2ND ADDENDUM TO FACT SHEET
Permit No. WA-000261-5
Todd Pacific Shipyards Corporation

This is an addendum to the fact sheet accompanying NPDES Permit No. WA-000261-5, which was issued to Todd Pacific Shipyards Corporation (Todd) on September 16, 2002. The following revision is made as the result of a recent change at the facility.

SITE PLAN – NORTHWEST CORNER OF TODD PACIFIC SHIPYARDS – SEATTLE
DRY DOCK # 1, #10, AND #3

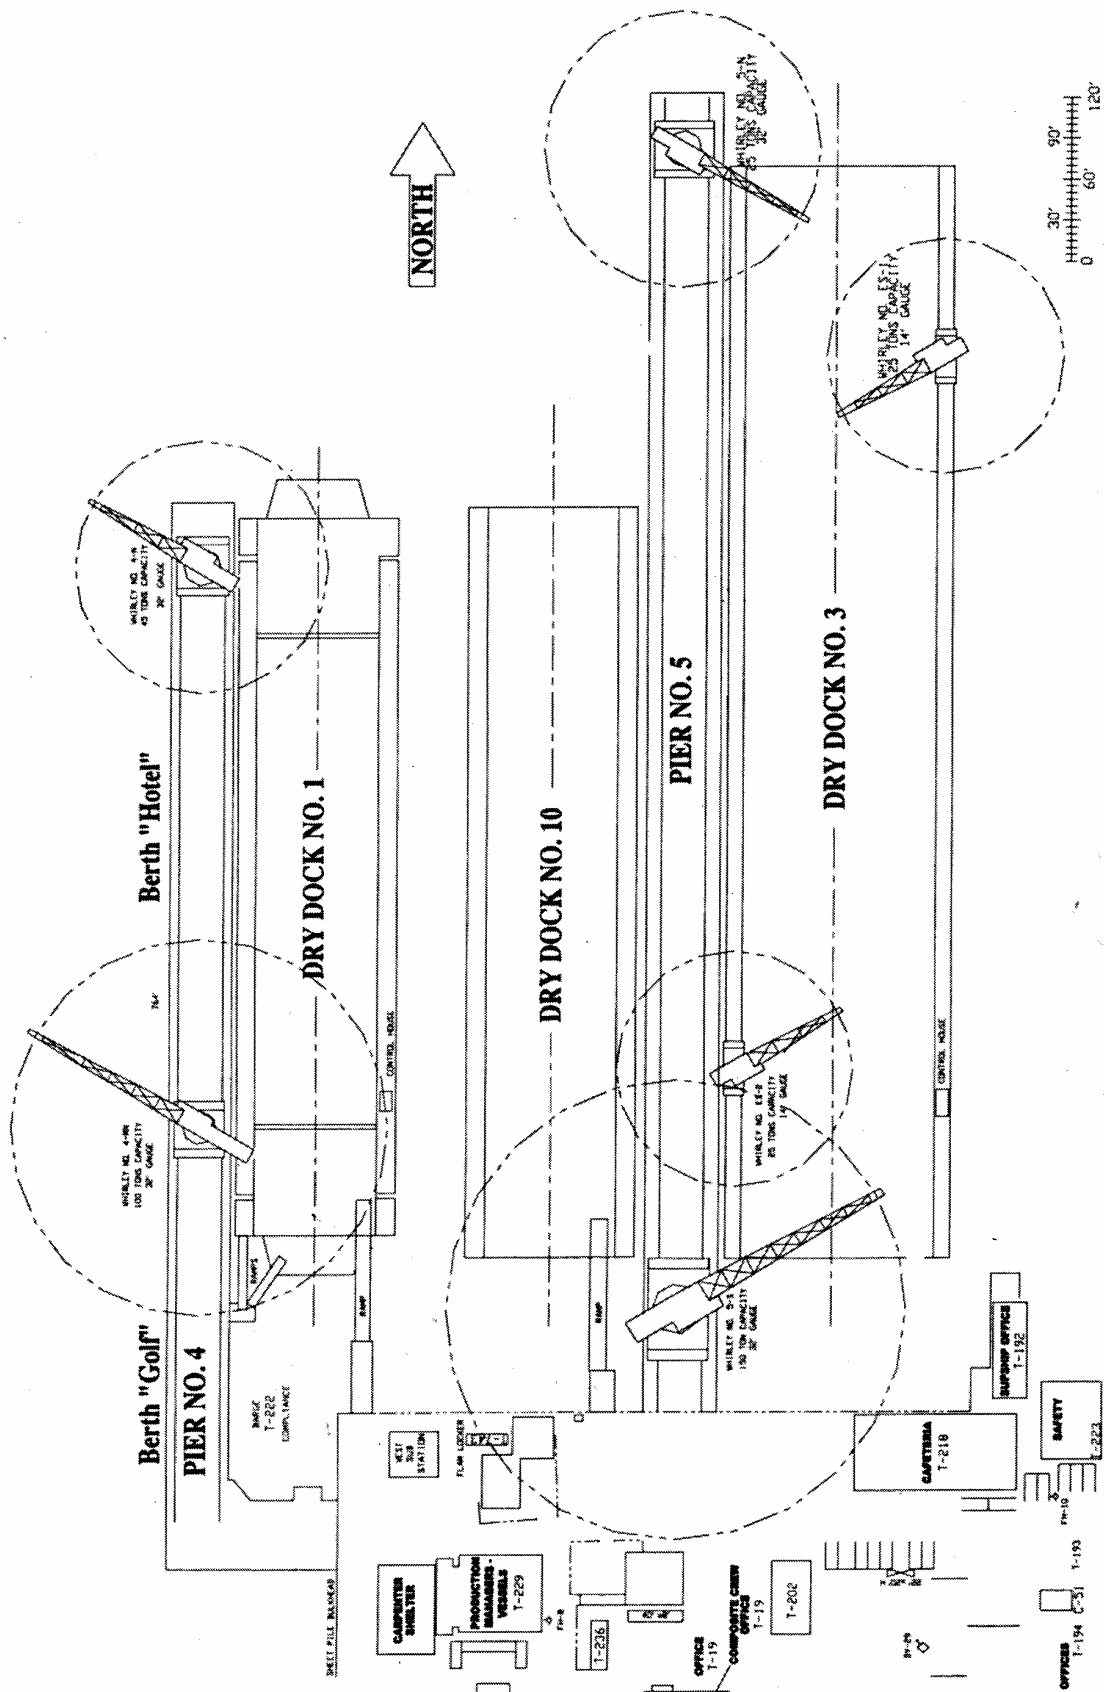
Special Condition S1.A.I on page 5 of the permit will be changed to designate Outfall 002 for wastewater from drydock #10. The new drydock #10 replaces drydock #2 which will be removed from service and demolished.

Drydock #10 is 552 feet long and 124 feet wide, and it will be located on the west side of the facility's Pier #5. Drydock #3 will be relocated to the east side of Pier #5 (see attached site map). Drydock #10 will be laid up on drydock #3 for repairs and modifications. Work not accomplished while in drydock #3 will be contained either within the drydock tanks or pontoon deck. It is expected that drydock #10 will be ready for operation by the end of January 2006.
